ROTOJET: the best got better!

Standard from May 2017 onwards!!

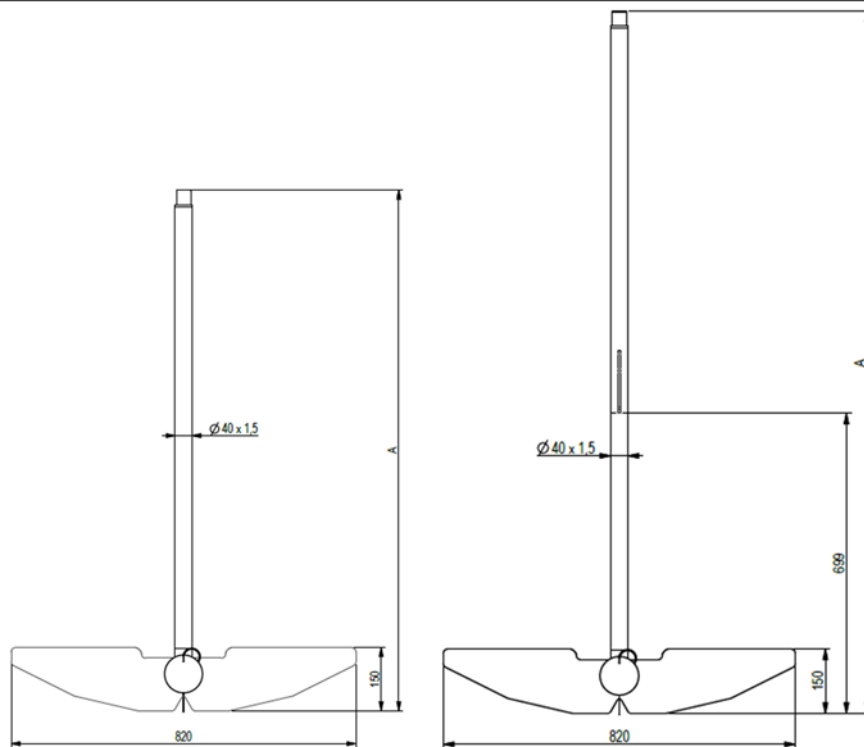
The new Rotojet will be standard for:

- New orders from **May 2017** onwards
- Exclusive in combination with the **iControl Eco-Wash**
- Only available for **horizontal**, closed **tanks**: REM-RS-RM/IB-LEM-LS

- An even **more powerful cleaning** thanks to the higher water pressure and wider cleaning pattern.
- Developed following the EHEDG and 3A principles of **hygienic design**
- A **more stable** position of the **agitator** thanks to the 'V'-opening on the bottom of the agitator blade. The opening allows the milk to pass through instead of pushing the milk upwards, back and forth, which should have a positive effect on the milk quality.
- An **optimized and robust** agitation and wash system

Type of tank	Part no.	Length (A)	# agitator blades
REM 1050 – 2100 RMIB 1600 - 2200	334991	932 mm	1
REM 2600 – 5000 RMIB 2800-5000	321931	1239 mm	1
REM 6150 – 8200 + RS 5000 RMIB 6000 - 7150	321932	1494 mm	2
REM 9000 – 15000 + RS 8000	321933	1639 mm	2
LEM 18000 – 31600 + LS 10250	327282	1990 mm	2
LS 13000 – LS 36000	319972	2364 mm	2
